# Stage 02: Industry Consultation

## GC0076 Grid Code Limits On Rapid Voltage Changes

This proposal seeks to modify the Grid Code limits on rapid voltage changes triggered by planned transmission system owner and transmission system User operations

**Figure 2-** Limits for Category 3 Rapid Voltage Changes

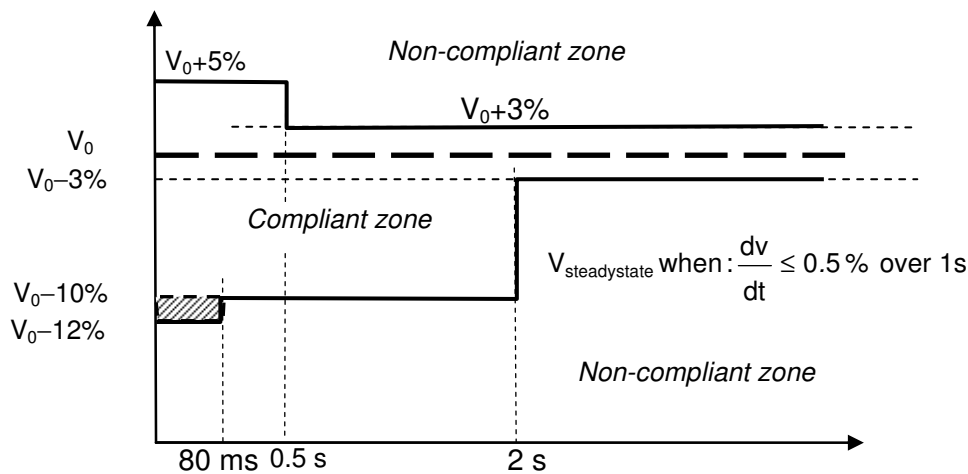
Category 3 Rapid Voltage Change

3.30 For this category of Rapid Voltage Changes, operations are restricted to those required for commissioning, planned maintenance and fault restoration which are infrequent in nature. The cost benefit case for applying tighter limits is weak in these situations as the cost of mitigation would be spread across a limited number of short occurrences.

3.31 The proposed time dependent characteristic is shown in Figure 2.

- 3) A steady state voltage is said to have been reached when  $dv/dt \leq 0.5\%$ , with reference to the rms of voltage averaged over 1 second;
- 4) The shaded area is proposed as it is in accordance with the 12% voltage change stipulated in NETS SQSS. The duration of the maximum allowable depth ( $V_0 - 12\%$ ) has been specified in coordination with fast acting voltage controllers;

- 5) The voltage changes specified are the absolute maximum allowed, applied to phase to ground or phase to phase voltages whichever is the highest. Thus in order to determine maximum voltage changes, assessments should consider propagation of voltage changes to other voltage levels through three phase transformers with different winding arrangements.

Figure CC6.1.7- Limits for Category 3 Rapid Voltage Changes

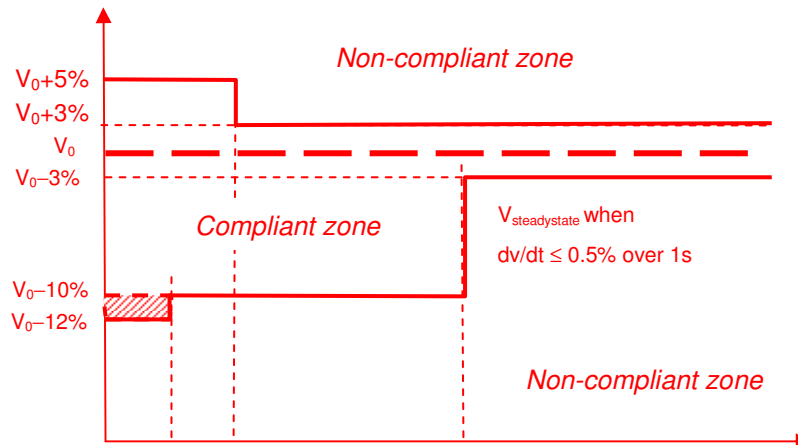
"CC.6.1.7 Voltage ~~fluctuations changes~~ at a **Point of Common Coupling** ~~with a fluctuating Load directly connected to on~~ the **Onshore Transmission System** shall not exceed:

- (a) ~~In England and Wales, 1% of the voltage level for step changes which may occur repetitively. Any large voltage excursions other than step changes may be allowed up to a level of 3% provided that this does not constitute a risk to the National Electricity Transmission System or, in NGET's view, to the System of any User. In Scotland, the limits for voltage level step changes are as set out in Engineering Recommendation P28. The limits specified in Table CC.6.1.7 with the stated frequency of occurrence, where:~~

Category	Maximum number of occurrences (n)	$\% \Delta V_{\max}$ & $\% \Delta V_{\text{steadystate}}$
1	No Limit	$\% \Delta V_{\max} \leq 1\%$ & $\% \Delta V_{\text{steadystate}} \leq 1\%$
2	For $n \leq 2$ per hour & $n > 4$ per day	$\% \Delta V_{\max} \leq 3\%$ & $\% \Delta V_{\text{steadystate}} \leq 3\%$
3	Commissioning, Maintenance and Fault Restoration up to $n \leq 4$ per day	$\% \Delta V_{\max} \leq 12\%$ & $\% \Delta V_{\text{steadystate}} \leq 3\%$ (see Figure CC6.1.7)

- (ii)  $V_0$  is the initial steady state system voltage;
- (iii)  $V_{\text{steadystate}}$  is the system voltage reached when the rate of change of system voltage over time is less than or equal to 0.5% over 1 second;
- (iv) All voltages are the rms of the voltage measured over one cycle refreshed every half a cycle as per IEC 61000-4-30;
- (v) The voltage changes specified are the absolute maximum allowed; applied to phase to ground or phase to phase voltages whichever is the highest;
- (vi) Voltage changes in category 3 do not exceed the limits depicted in the time dependant characteristic shown in Figure CC.6.1.7; and
- (vii) Voltage changes in category 3 only occur in circumstances notified to **NGET** such as for example commissioning in accordance with a commissioning programme, implementation of a planned outage

For connections with a **Completion Date** after 1<sup>st</sup> September 2014, **Bilateral Agreements** may include provision for **NGET** to reasonably limit the number of voltage changes in category 2 or 3 to a lower level than specified in Table CC.6.1.7 to ensure that the total number of changes at the **Point of Common Coupling** across multiple **Users** remains within the limits of Table CC.6.1.7.
